Port of Leith – Outer Berth

Environmental Impact Assessment Report Addendum
(including additional information to support the Habitats
Regulations Appraisal)

Reference: PC2045-RHD-ZZ-XX-RP-Z-0010

Operational Lighting Plan

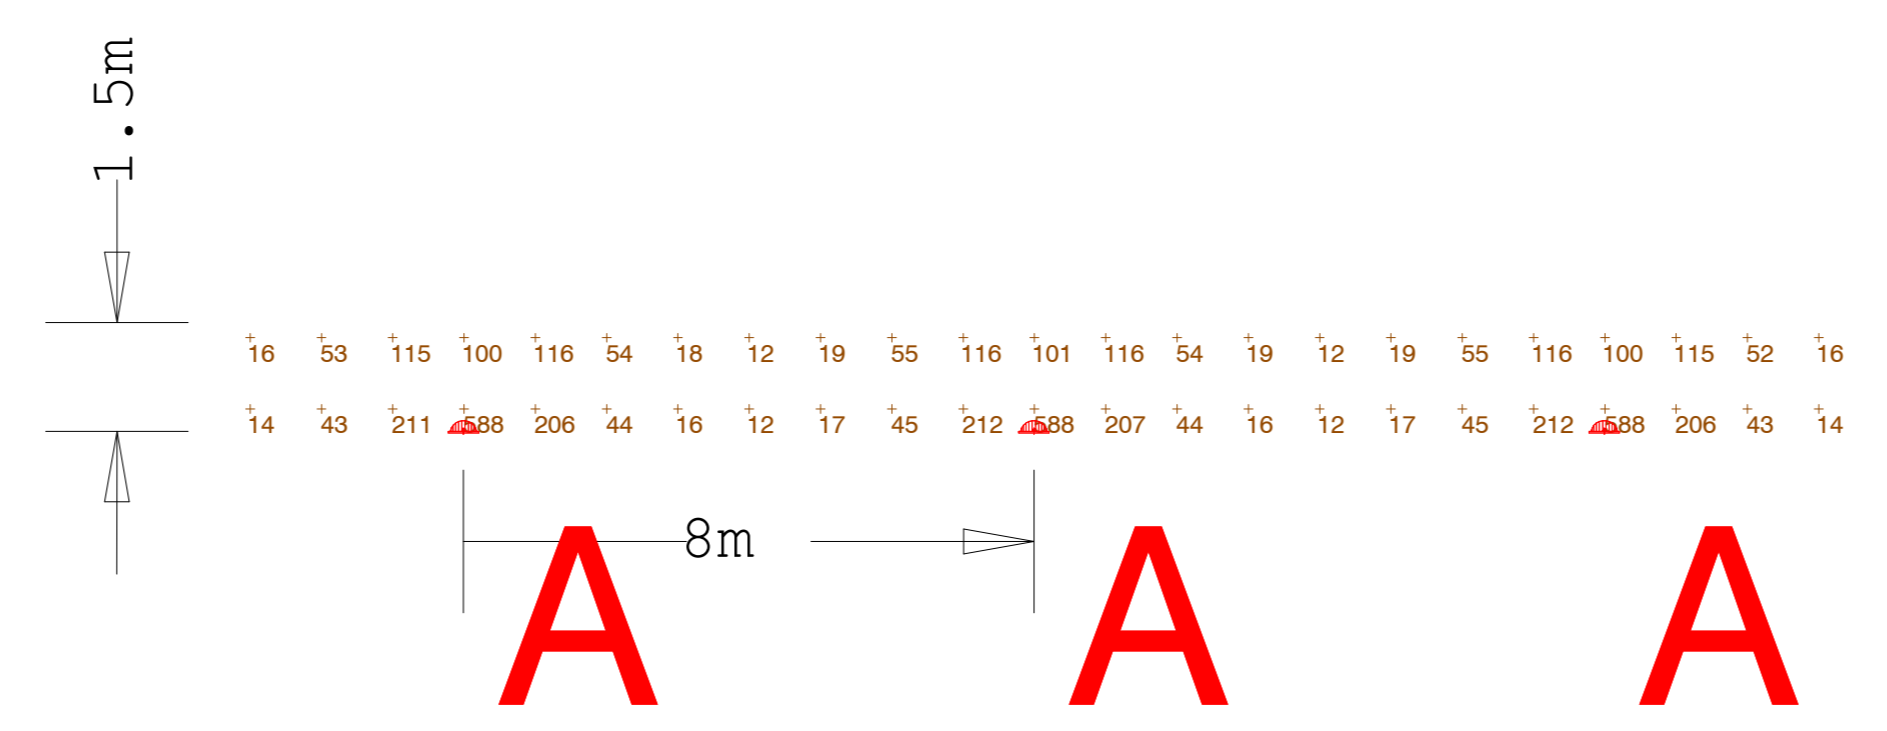
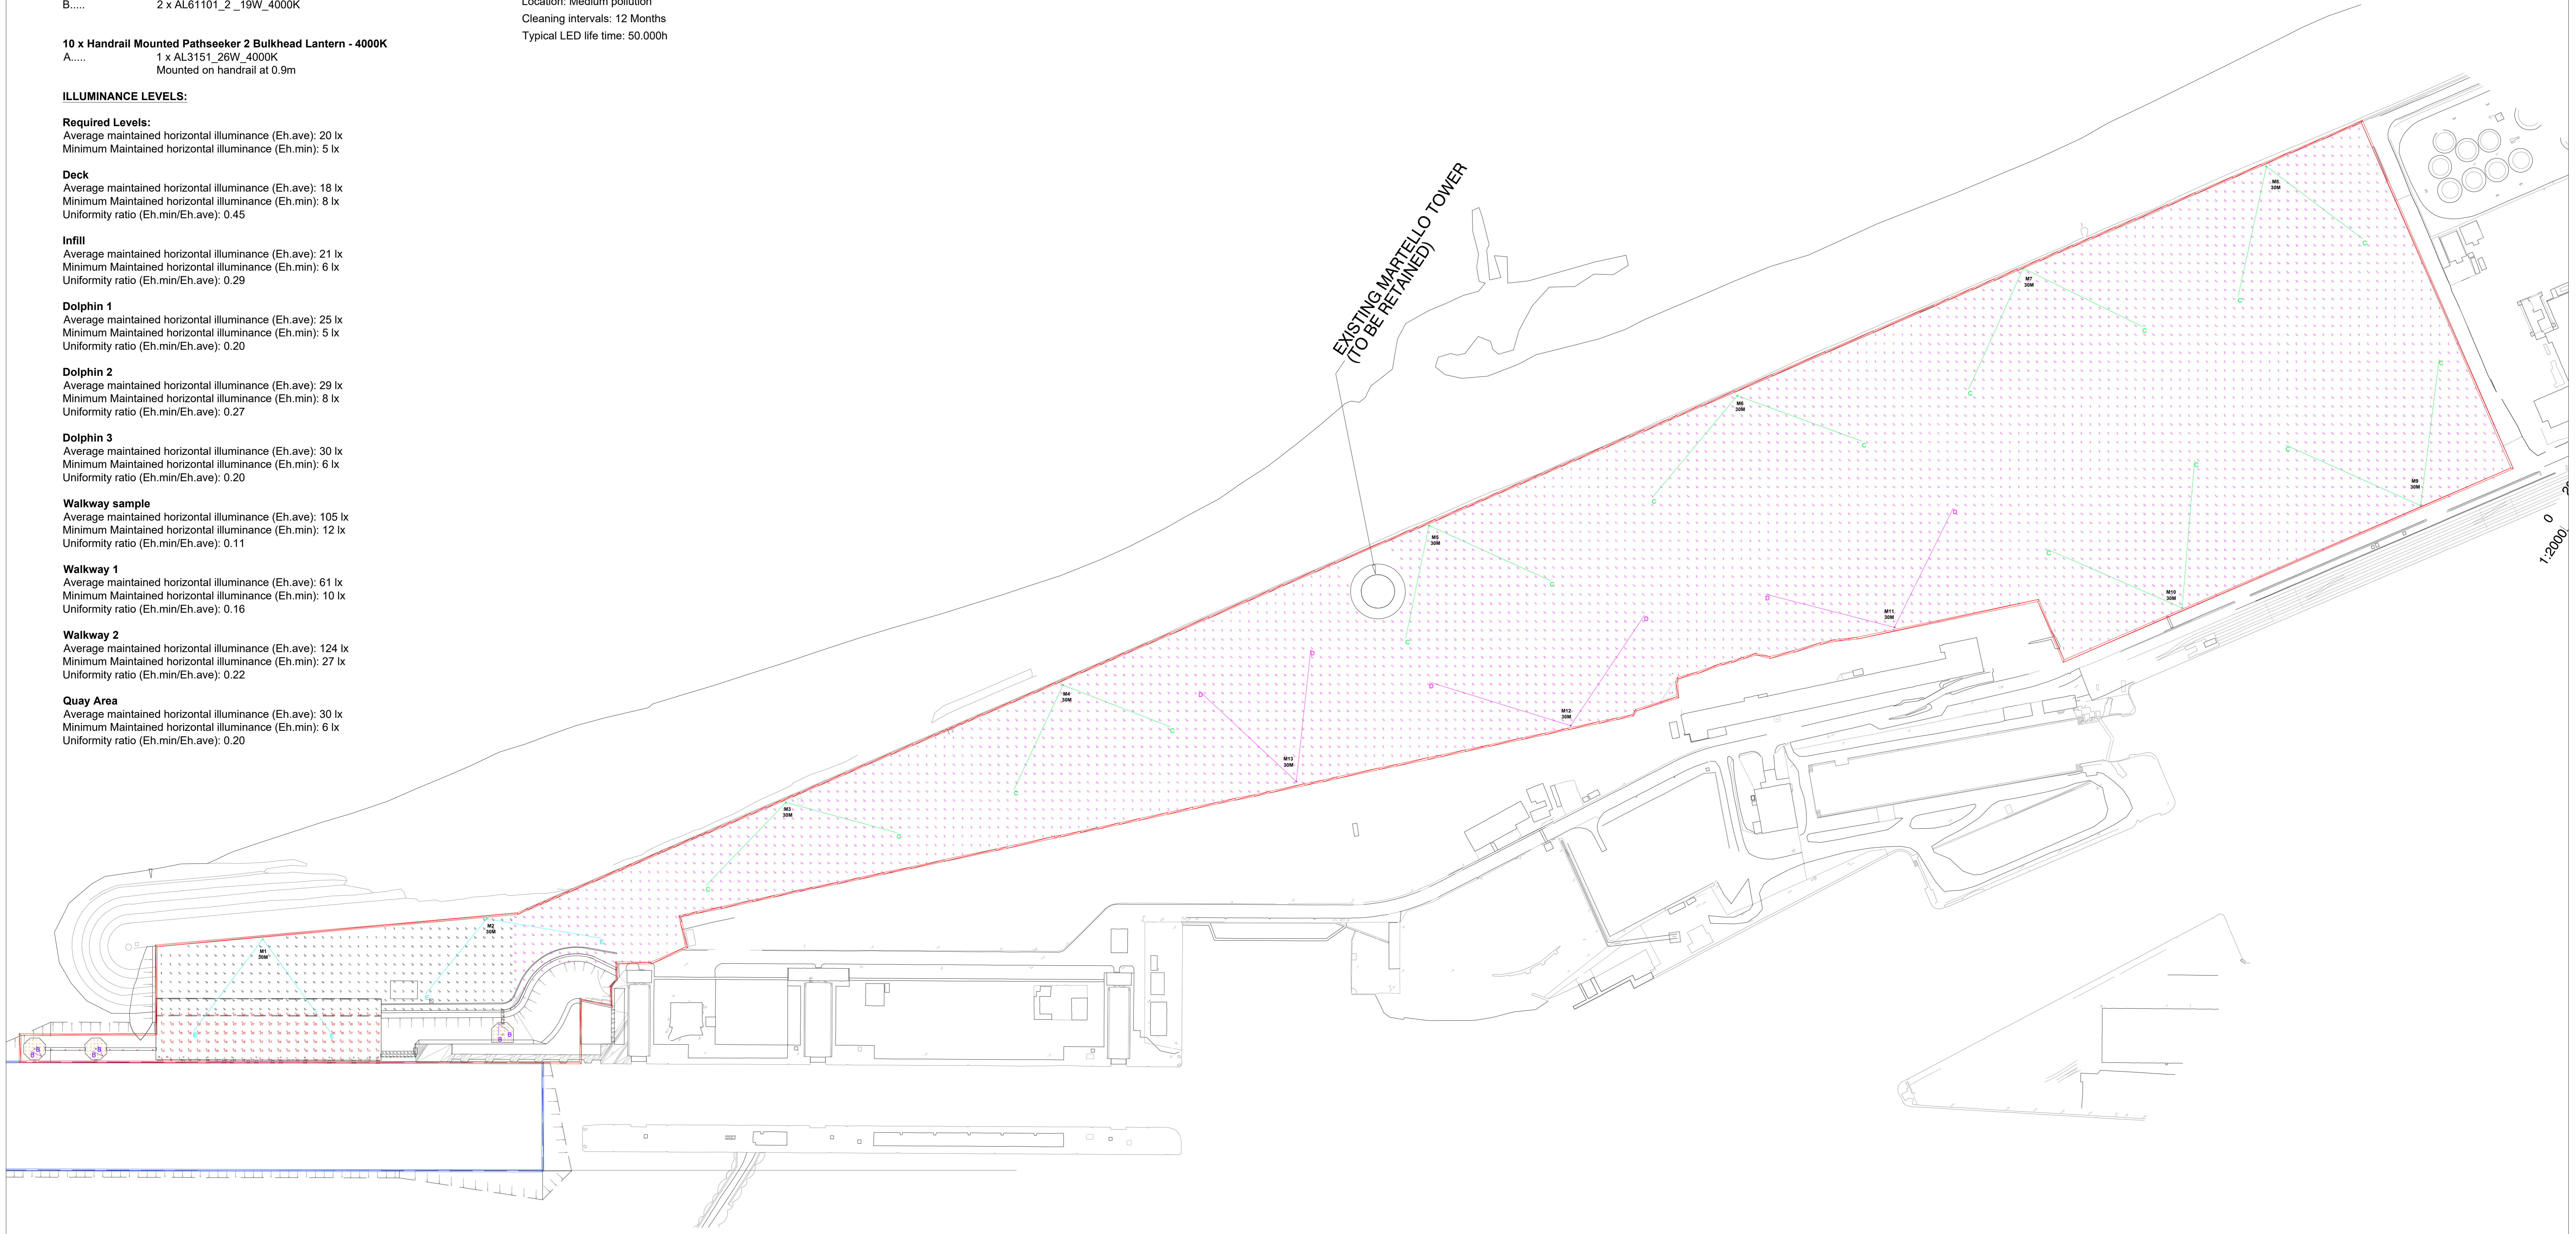
2	The Scottish Ministers request further information in relation to the impact on bird species at the site of the Proposed Development caused by artificial lighting during both the operational and construction phases of the Proposed Development. This should include a description of the lighting plan during both the construction and operation phases, any potential impacts particularly in relation to bird species, including but not limited to breeding terns, and any required mitigation in light of the impacts identified.	<p>It is not considered appropriate to provide a construction lighting plan given the temporary and localised effects that would occur. Rather best practice measures will be adhered to as described and approved via the required Construction Environmental Management Plan (CEMP).</p> <p>An operational lighting plan has been produced, see Appendix C. The lights are shielded and the design intent is to provide lighting of the work area and not anywhere else. In addition, 3000°K lighting is proposed which, given its warmer output, reduces any impact to light sensitive wildlife that may use the site.</p>

- The Scottish Ministers request further information in relation to the impact on bird species at the site of the Proposed Development caused by artificial lighting during both the operational and construction phases of the Proposed Development. This should include a description of the lighting plan during both the construction and operation phases, any potential impacts particularly in relation to bird species, including but not limited to breeding terns, and any required mitigation in light of the impacts identified.

Walkway 1
 Average maintained horizontal illuminance (Eh.ave): 61 lx
 Minimum Maintained horizontal illuminance (Eh.min): 10 lx
 Uniformity ratio (Eh.min/Eh.ave): 0.16

Walkway 2
 Average maintained horizontal illuminance (Eh.ave): 124 lx
 Minimum Maintained horizontal illuminance (Eh.min): 27 lx
 Uniformity ratio (Eh.min/Eh.ave): 0.22

Quay Area
 Average maintained horizontal illuminance (Eh.ave): 30 lx
 Minimum Maintained horizontal illuminance (Eh.min): 6 lx
 Uniformity ratio (Eh.min/Eh.ave): 0.20

Figure: F.1 Drawing No: PC2045-RHD-ZZ-ZZ-DR-EV-0049

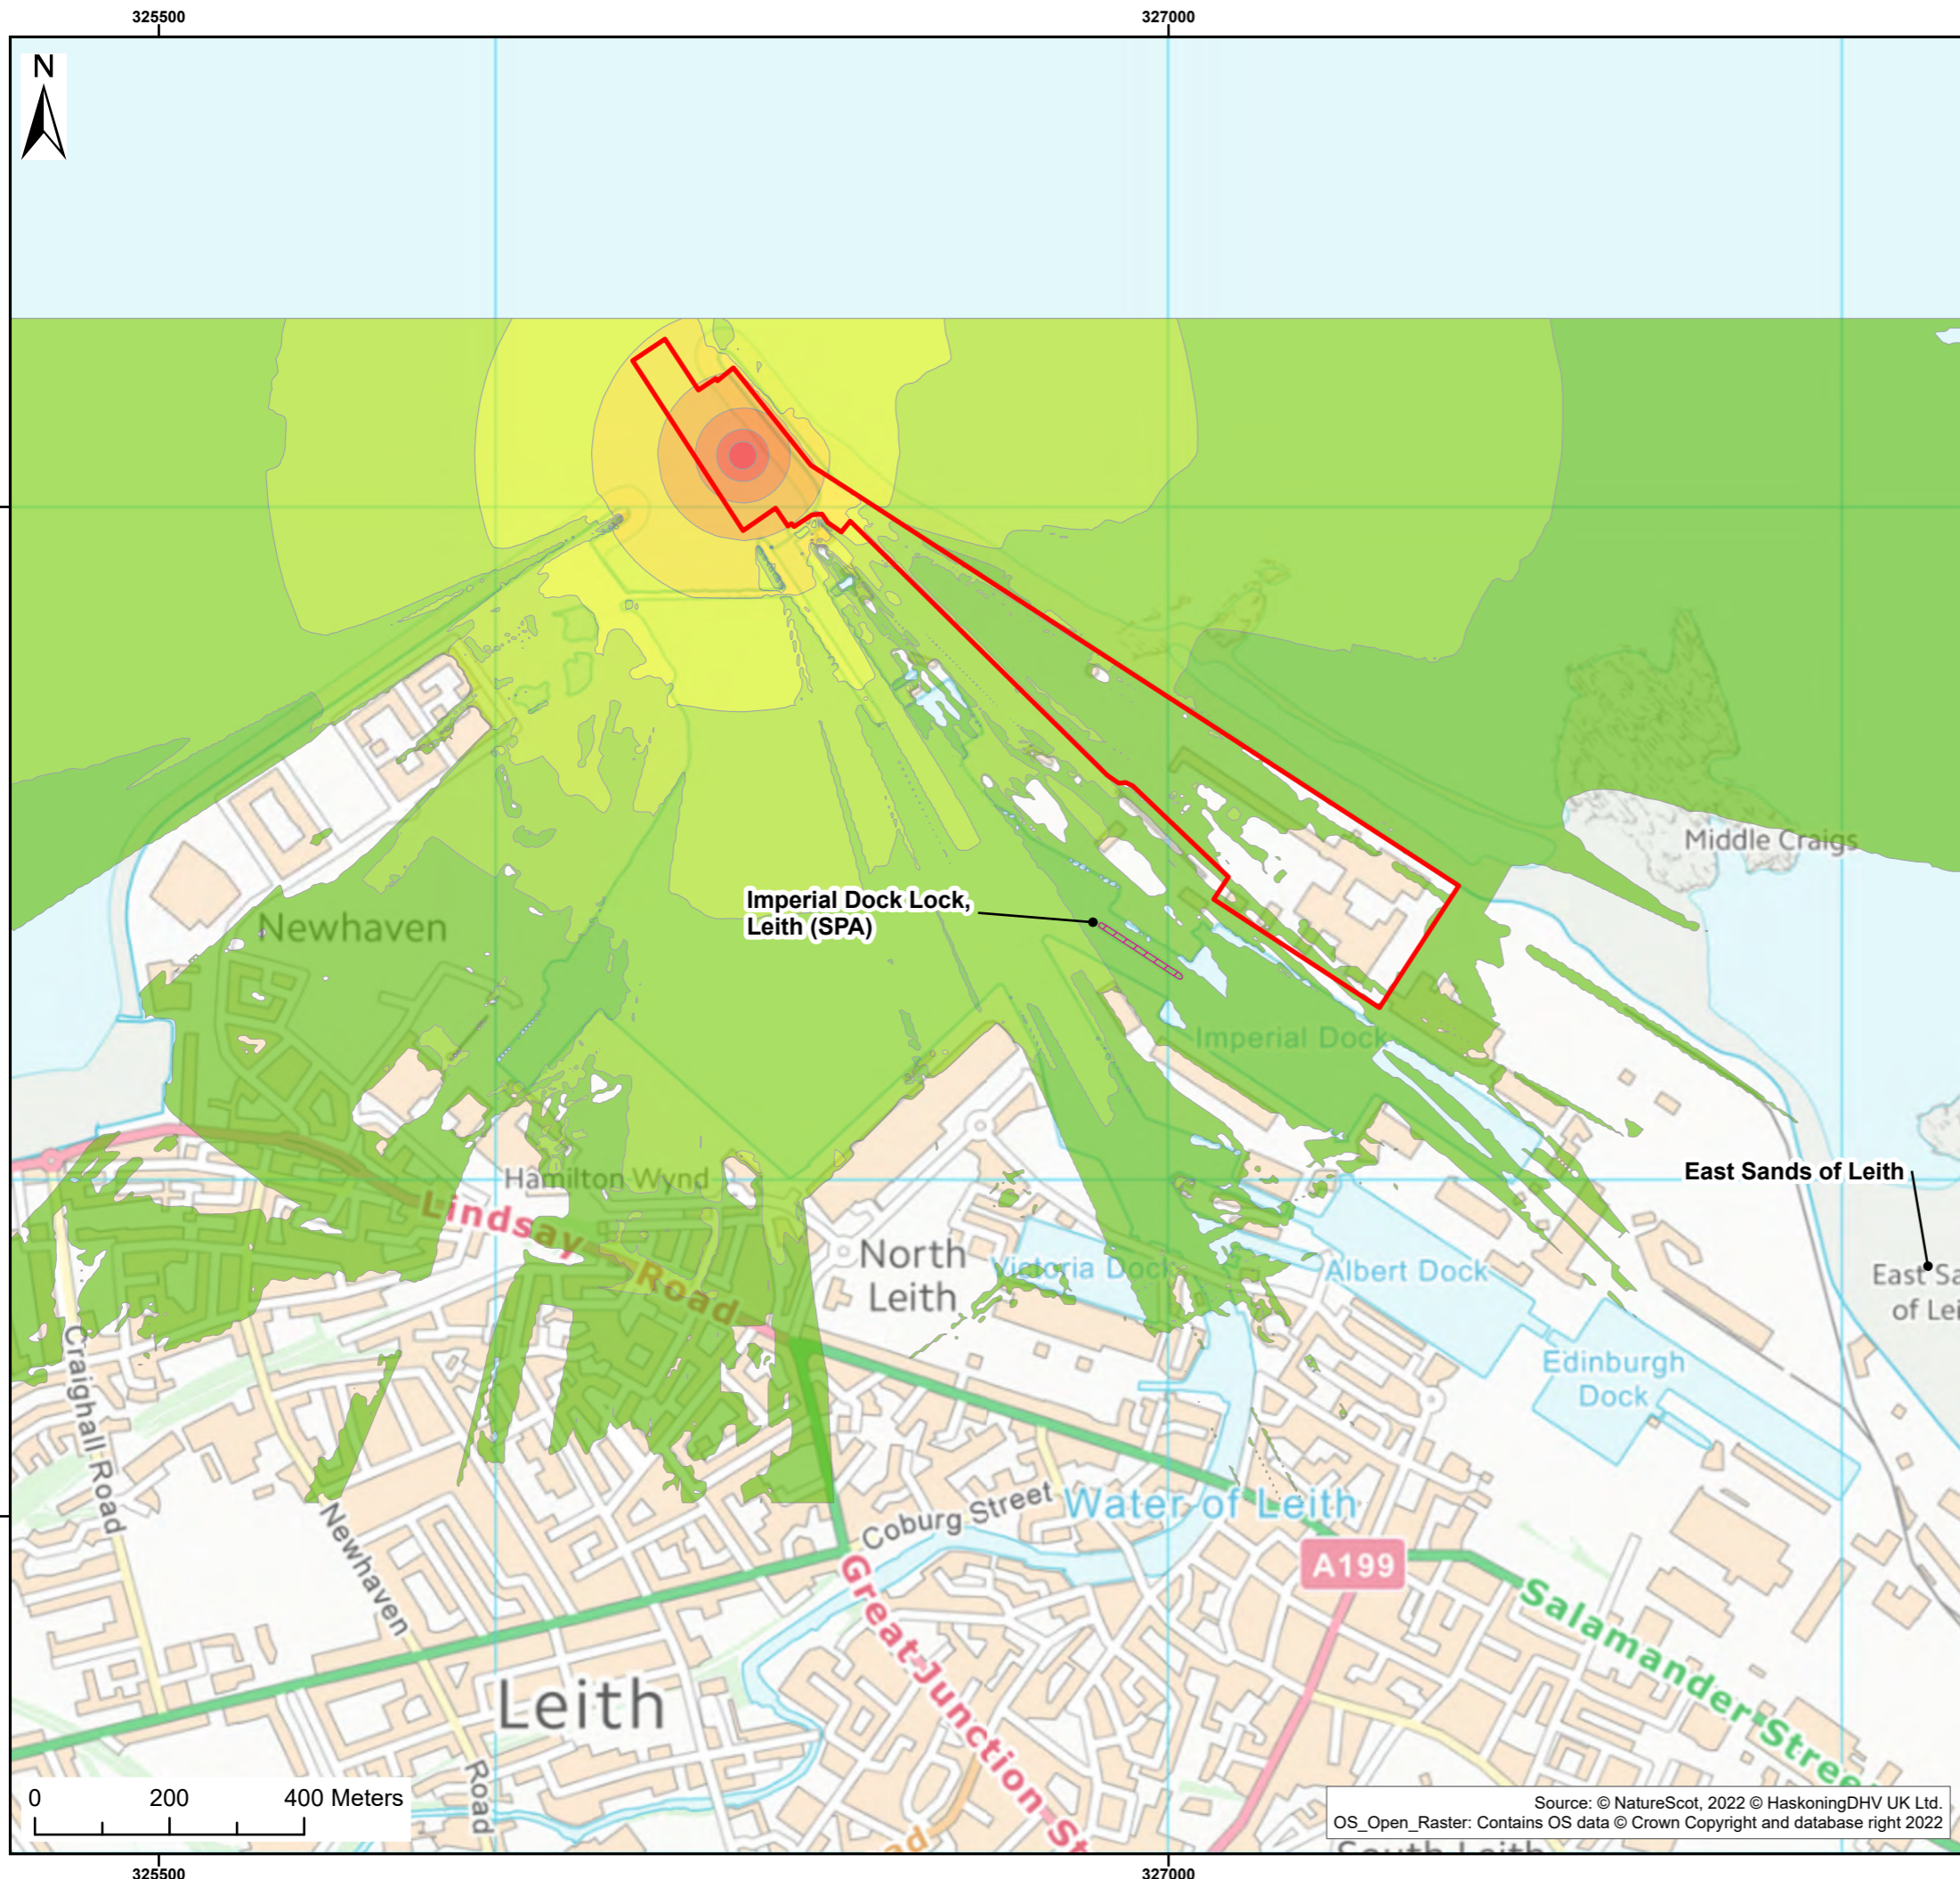
7	<p>The Scottish Ministers request further information relating to the use of the piling shroud including modelling of noise impacts both with and without the shroud in order to provide an assessment of the potential noise abatement against all underwater noise impacts generated by the Works.</p>	<p>The shroud provides mitigation for airborne noise rather than underwater noise. Measures to mitigate underwater noise have been proposed and approved by NS, subject to minor amendments (see Section 3).</p>
8	<p>The information should be supplied to MS LOT either as an addendum to the EIA Report already received or contained within a revised EIA Report. In regard to timelines going forward, once this information has been received, and in accordance with Section 22 of the 2017 EIA Regs, notice of the additional information must be published in the Edinburgh Gazette and in one or more newspapers circulating in the locality in which the works are situated and on the application website. The Scottish Ministers must also carry out consultation on the additional information provided with all public bodies that have an interest in the proposed works in line with s.18(1)(a)(iii) of the 2017 EIA Regs. The 2017 EIA Regs mandate at least a 30 day period from the last date of publication of the public notice and consultation to allow responses to be provided. In addition to this 30 day period, the Scottish Ministers will require a period of at least two weeks to come to a decision on the application once all consultation responses have been received and the 30 day notice period has expired, provided no further issues are raised during consultation. Please note that further time may also be required by</p>	<p>This document comprises the EIAR addendum as required by MS LOT.</p>

- The Scottish Ministers request further information relating to the use of the piling shroud including modelling of noise impacts both with and without the shroud in order to provide an assessment of the potential noise abatement against all underwater noise impacts generated by the Works.
